Service Bulletin

SEB95-19

LOWER FORWARD DOORPOST AND STRUT FITTING INSPECTION AND MODIFICATION

Figure 1. Lower Doorpost Bulkhead and Wing Strut Fitting Inspection (Sheet 2)

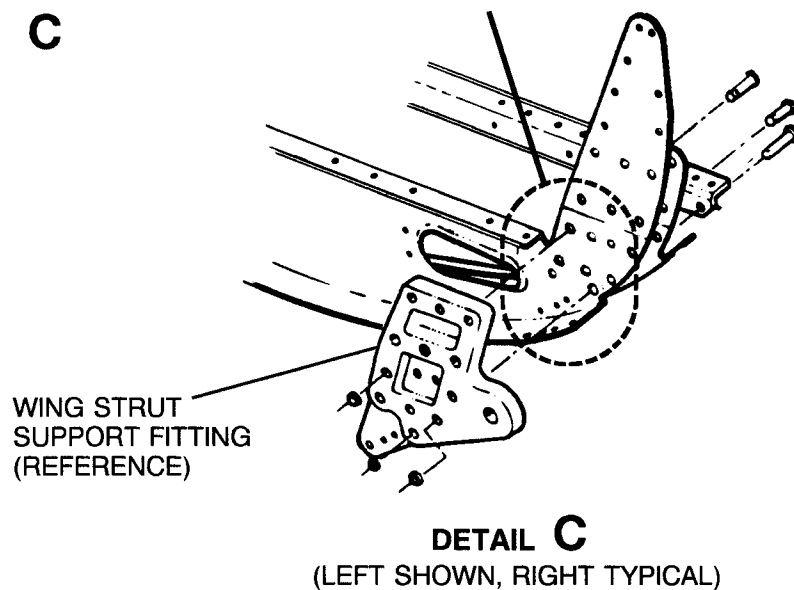
- C. Remove floorboard inspection covers in areas fore and aft of doorpost.
 - B. (Refer to Figure 1, Sheet 2, Details B and C.) Visually inspect areas shown for cracks. If there are cracks present, they should be visible at the intersection of the doorpost and the forward doorpost bulkhead. Look for cracks that follow the contour of the wing strut support fitting.

- D. If cracks are present:
 - (1) For 172, F172, R172, FR172 and 172RG model airplanes, install SK172-147 (or later revision) prior to further flight.

- (2) For 182, R182, TR182, A182, F182 and F182RG model airplanes, install SK182-115 (or later revision) prior to further flight.
 - (3) For 210-5 (205), 210 and T210 model airplanes, install SK210-156 (or later revision) prior to further flight.

Figure 1. Doorpost Bulkhead and Wing Strut Fitting Reinforcement (Sheet 2)

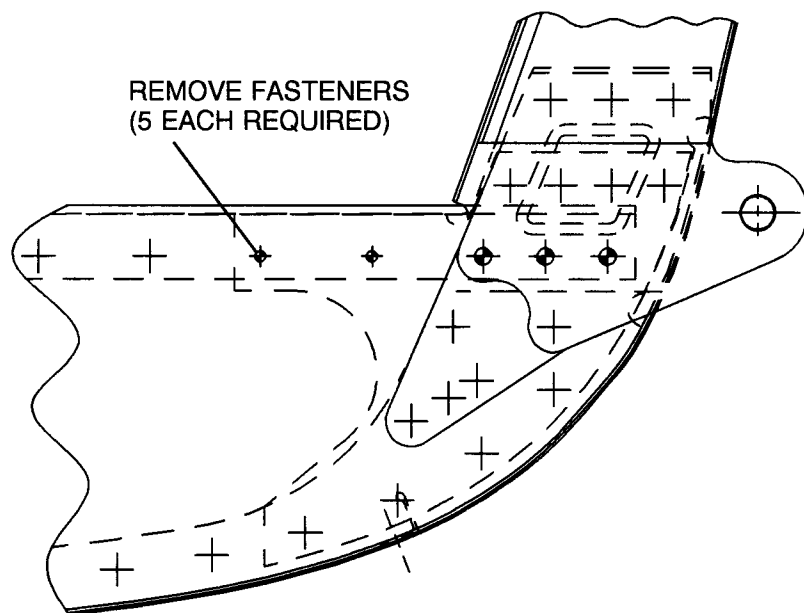
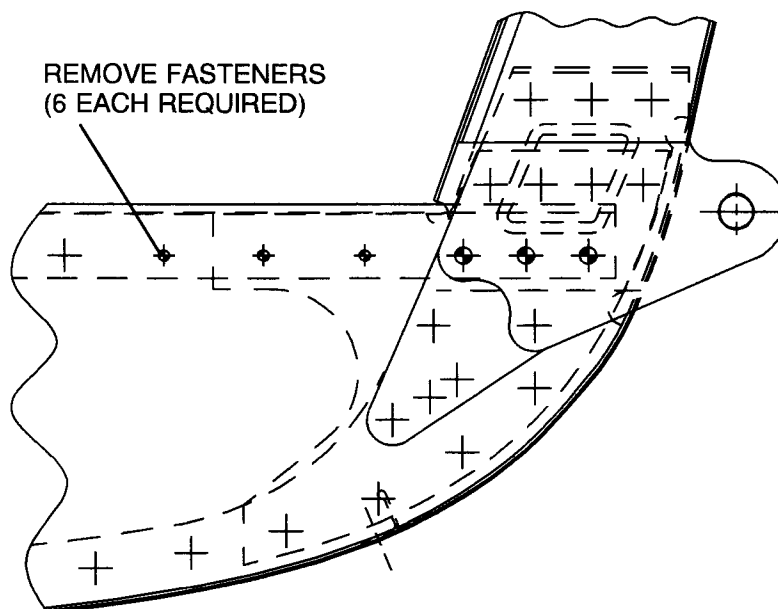
10. Remove or move fuel lines, wiring, cables, etc., as required to accomplish the remaining instructions.
11. (Refer to Figure 1, Sheet 2, View A-A, Before Modification.) Remove fasteners from the doorpost and bulkhead area. Drill out rivets and grind off Hi-Lok fastener collars to remove Hi-Lok fasteners. Do not enlarge fastener holes in the structure.

Figure 1. Doorpost Bulkhead and Wing Strut Fitting Reinforcement (Sheet 3)

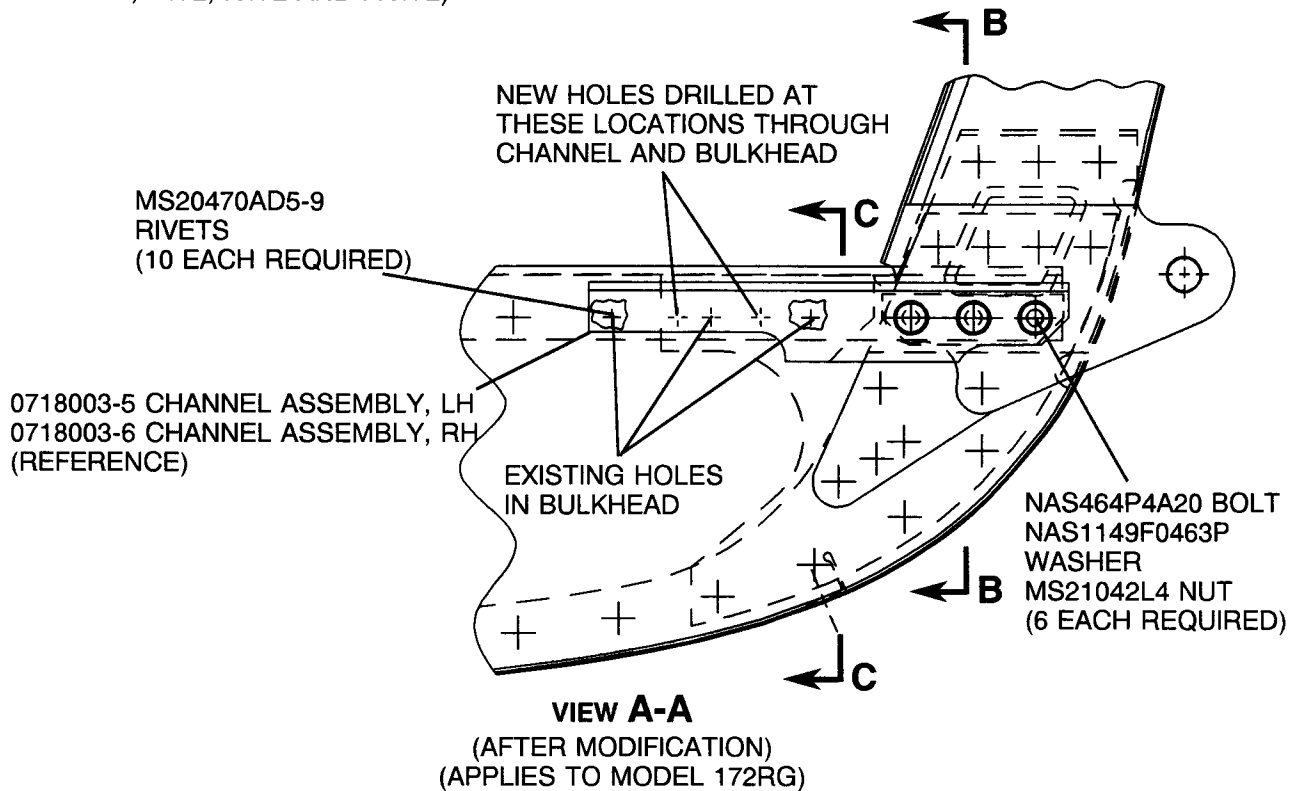
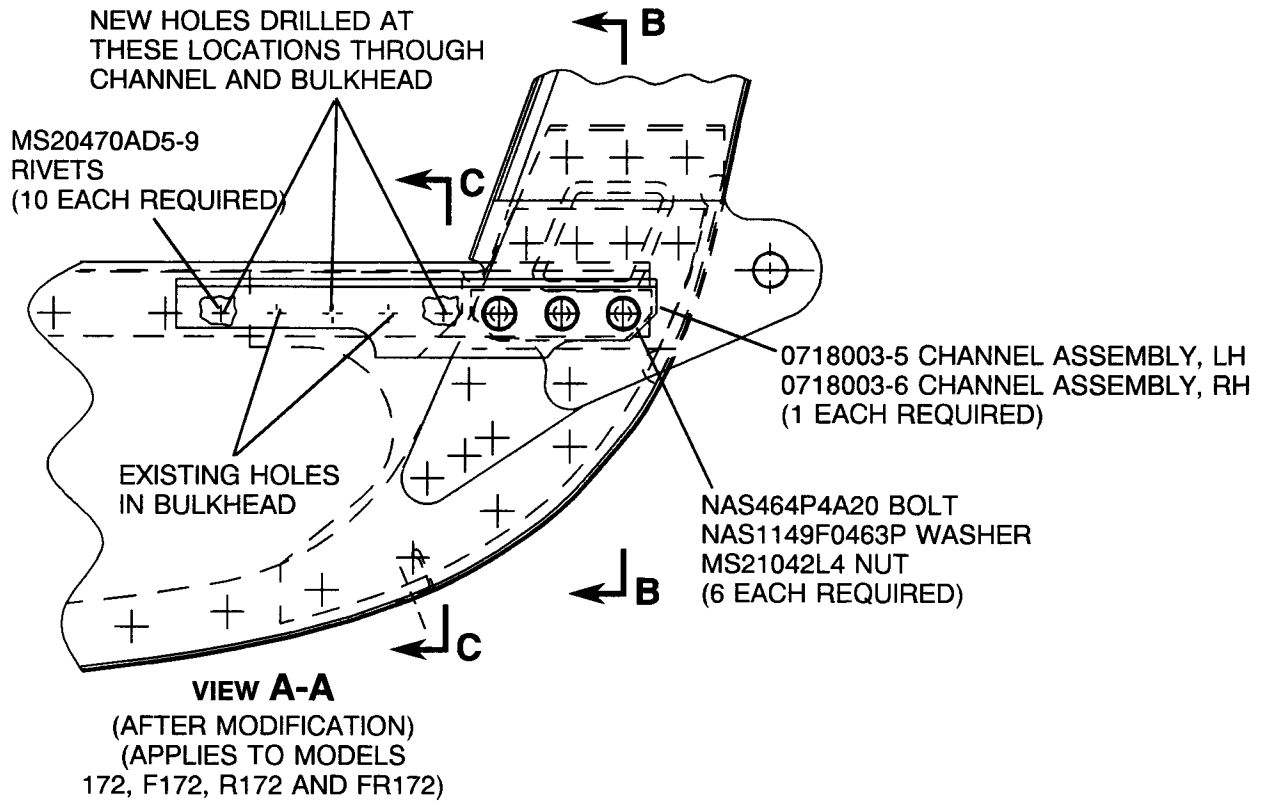
13. (Refer to Figure 1, Sheet 3, View A-A.) Drill additional 0.159 inch diameter (Number 21) holes through the bulkhead and channel for installation of MS20470AD5-9 rivets. Hole spacing should be approximately equal between the existing holes and the new holes.

NOTE: Ensure that new holes are not located on either of the joggles which exist on the backside of the bulkhead.

Figure 1. Doorpost Bulkhead and Wing Strut Fitting Reinforcement (Sheet 4)

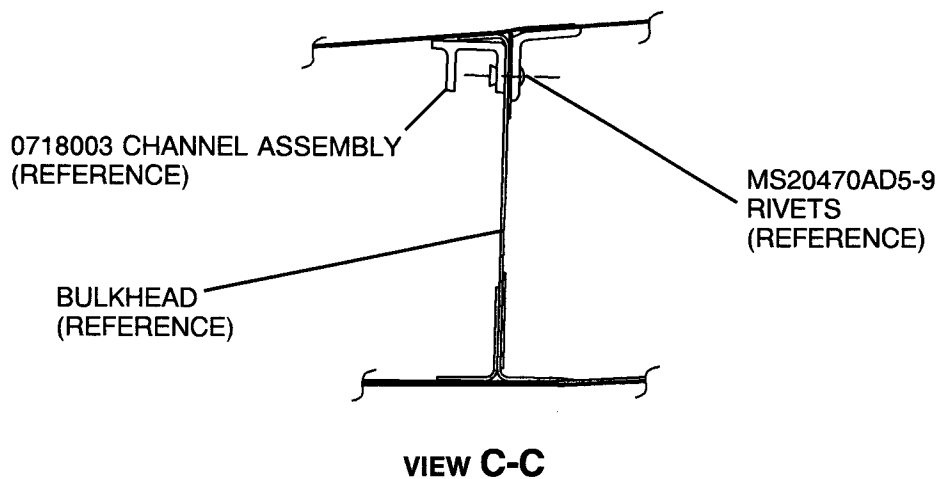
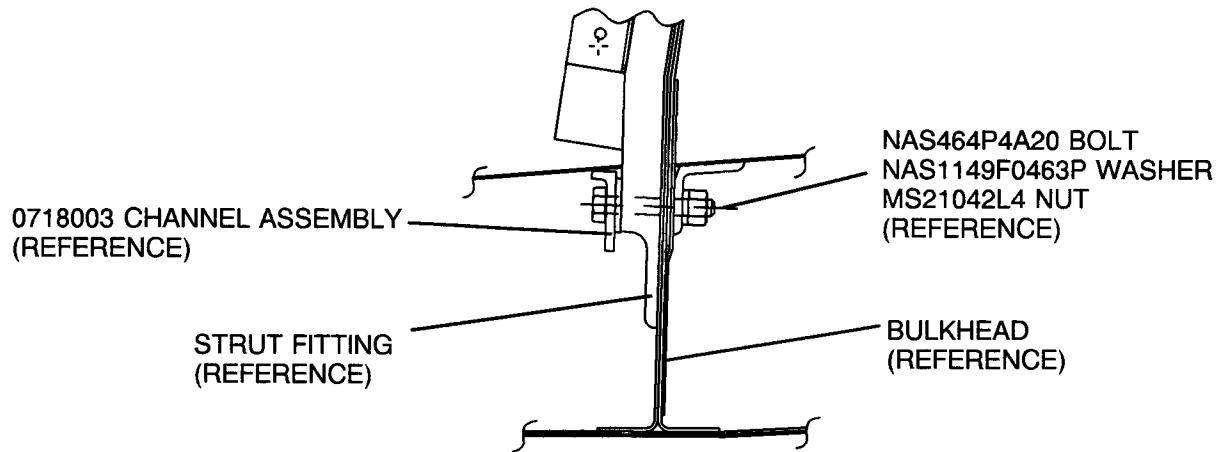
12. (Refer to Figure 1, Sheet 4, View B-B.) Position the 0718003-5 channel assembly on the forward side of the left strut fitting. Install a NAS464P4A20 bolt with washers and nut to retain in position. Using the bulkhead as a drill guide, drill holes in the channel to match existing holes in the bulkhead.

16. (Refer to Figure 1, Sheet 3, View A-A, and Sheet 4, Views B-B and C-C.) Install the channel assemblies to the bulkhead using provided fasteners as shown.

Figure 2. Doorpost Bulkhead and Wing Strut Fitting Reinforcement (Sheet 3)

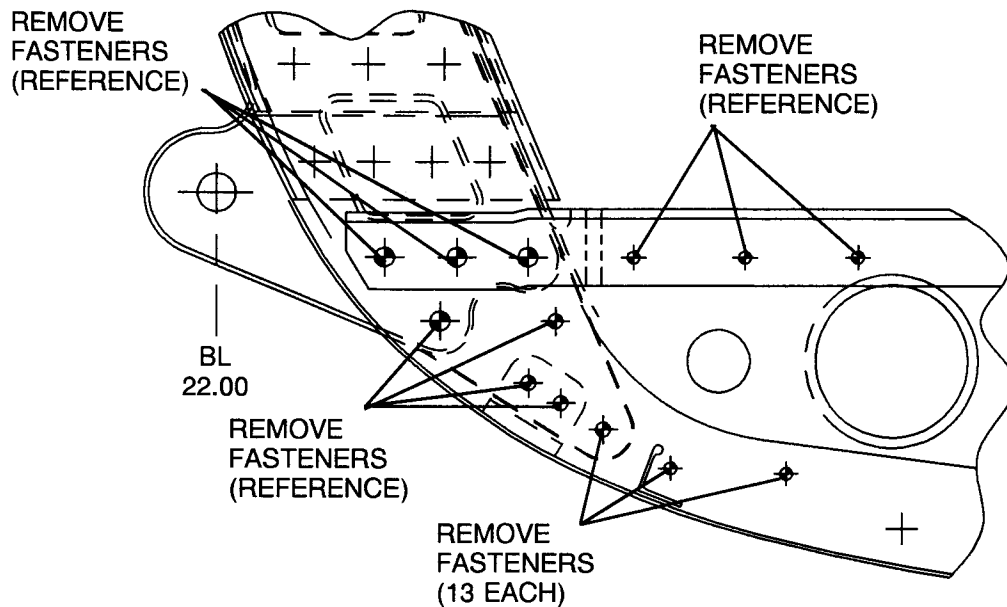
9. Remove and cap fuel lines along bulkhead area.
10. (Refer to Figure 2, Sheet 3, View B-B, Before Modification.) Remove fasteners from the doorpost. Drill out rivets and grind off Hi-Lok fastener collars to remove Hi-Lok fasteners. Do not enlarge fastener holes in the structure.

16. (Refer to Figure 2, Sheet 3, View B-B After Modification.) Drill 4 additional holes in each doubler at location shown to accommodate the MS20470AD5-8 rivets.

18. (Refer to Figure 2, Sheet 3, View B-B.) Final install the doublers and channel assemblies on the left and right side using the provided fasteners.

NOTE: On each side, two holes are fastened using HL18PB5-8 pins and HL70-5 collars. These holes must be reamed to a diameter of 0.1625 inch before installing pins.
19. Reinstall the fuel lines removed in step 9.
20. Refuel the airplane and check for leaks in the doorpost area. Correct any leaks as required.
21. Install the 0791207-2 forward access cover (typical for both left and right side):
 - A. Position the forward access cover over hole cut in step (7)(A). Lightly trace pattern onto existing floorboard and remove cover.
 - B. (Refer to Figure 1, Sheet 3, View A-A, After Modification.) Drill out all rivets within the traced pattern. Match drill holes in the 0791207-2 access cover to match floorboard holes.

Figure 2. Doorpost Bulkhead and Wing Strut Fitting Reinforcement (Sheet 5)

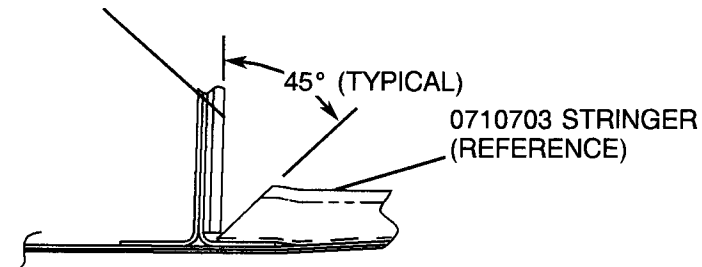
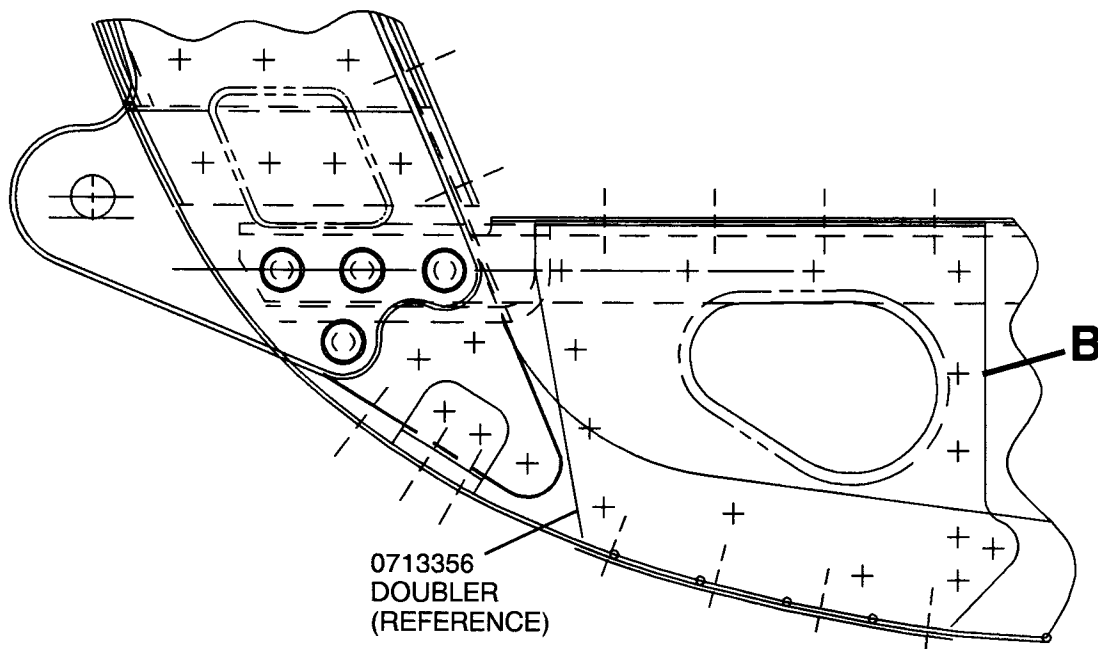
11. (Refer to Figure 2, Sheets 5 and 6, View F-F and Detail B.) Model 182 serials 18267716 thru 18268434, and Model R182 serials R18201629 thru R18202039 airplanes have a 0713356 doubler installed on the right side forward face of the doorpost bulkhead that will require modification. Drill out rivets and remove the doubler. Modify the doubler by trimming off the upper section as shown. Reinstall the doubler.

13. (Refer to Figure 2, Sheet 5, View E-E.) Trim the forward end of the 0710703 (-3 left; -4 right) stringers to allow the installation of the 1211903 (-3 left; -4 right) doubler.

Figure 1. Floorboard Modification (Sheet 3)

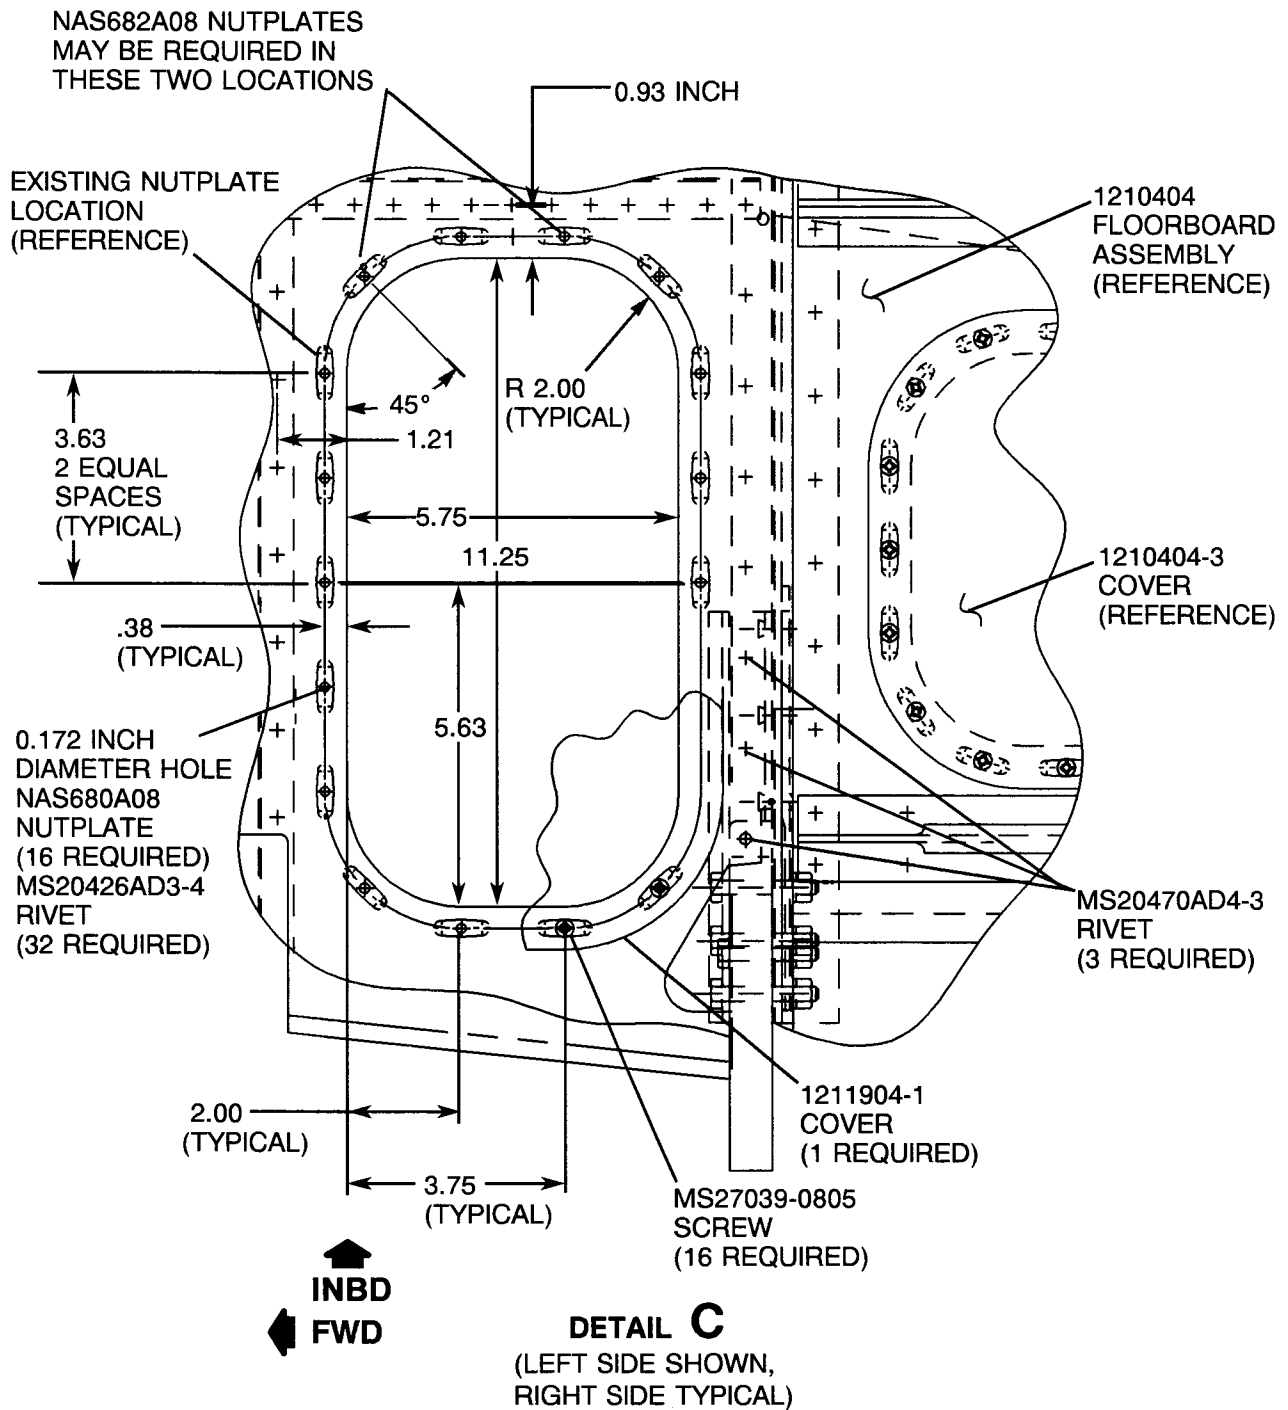
10. Lay out lines and enlarge round cutouts in the floorboard forward of the doorpost. (Refer to Figure 1, Sheet 2, View A-A, and Sheet 3, Detail C.)
11. Remove existing PK style nutplates used to secure the round access cover plates.

12. (Refer to Figure 1, Sheet 3, Detail C.) Picking up existing nutplate locations, locate and drill 11/64 (0.172 inch diameter) nutplate center holes. Locate and drill the remainder of 32 each Number 40 (0.098 inch diameter) holes nutplate attach rivet holes. Countersink the Number 40 holes 0.182×100°. Install 16 each NAS680A08 and NAS682A08 nutplates using MS20426AD3-4 rivets. Repeat the procedure for the right side. (Refer to Figure 1, Sheet 4, Detail E.)

- C. All other serial number airplanes remove the existing rivets in the same locations as the above mentioned nutplates. Countersink the holes on the bottom side of the structure 0.225 inch diameter × 100°. Obtain the MS20470AD4-3 rivets from the kit and install with the manufactured head on the bottom. (Refer to Figure 1, Sheet 3, Detail C.)

Figure 1. Floorboard Modification (Sheet 5)

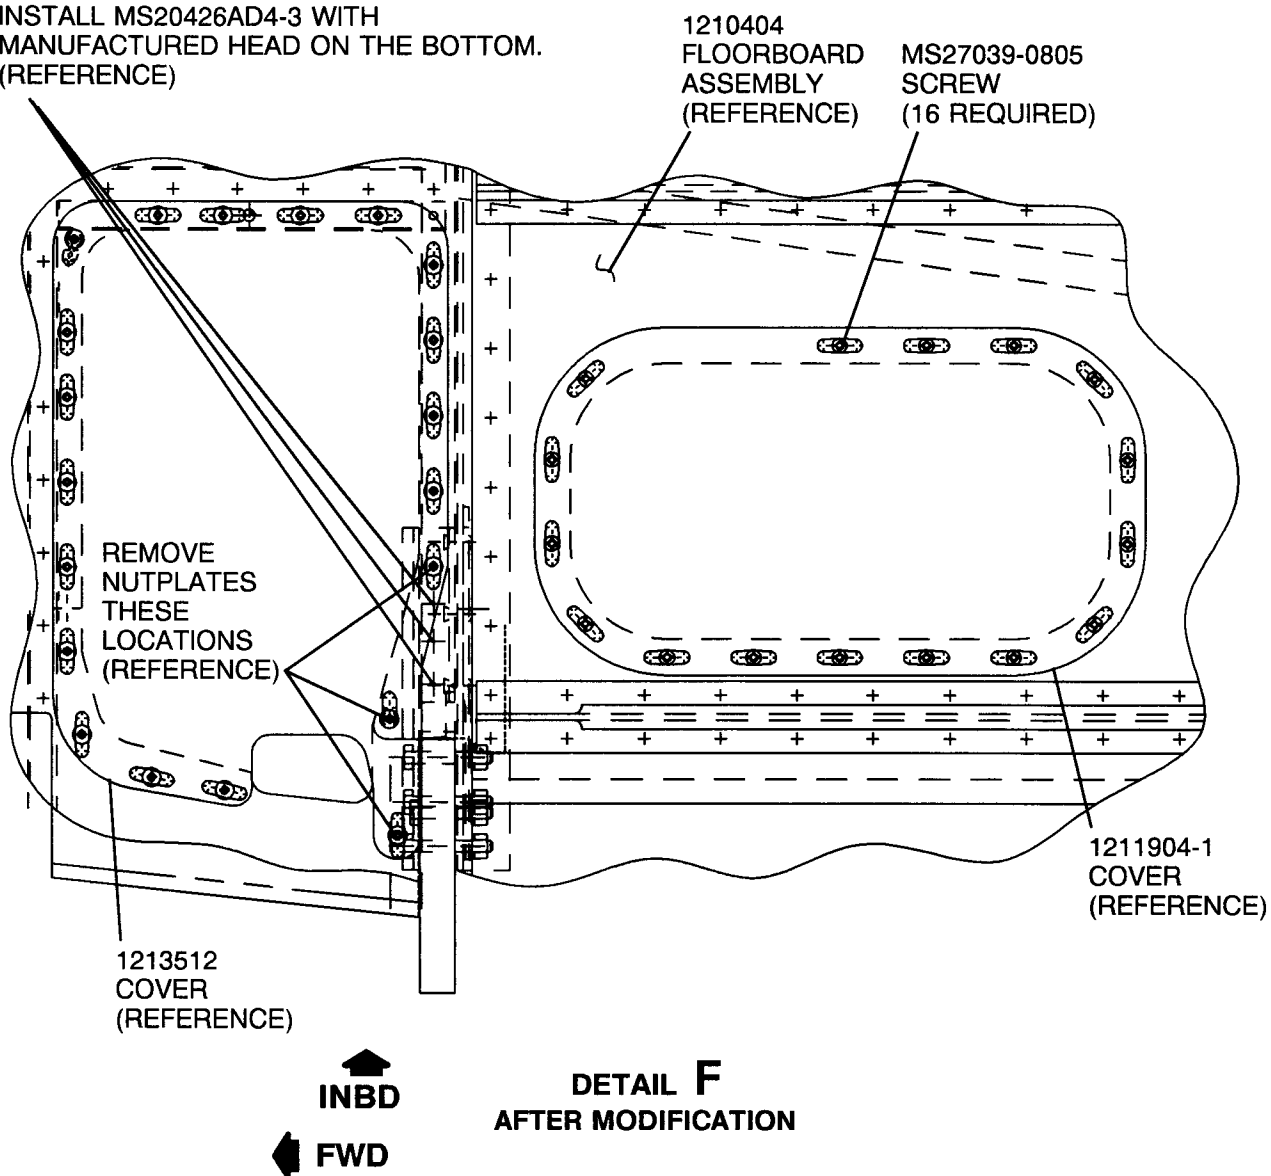
- A. Remove and discard the three nutplates. (Refer to Figure 1, Sheet 5, Detail F.)
 - B. Remove the three rivets. Countersink the holes on the bottom side of the structure 0.225 inch diameter × 100°. Obtain the MS20426AD4-3 rivets from the kit and cutoff as required to double flush the rivets. Install with the manufactured head on the bottom. (Refer to Figure 1, Sheet 5, Detail F.)
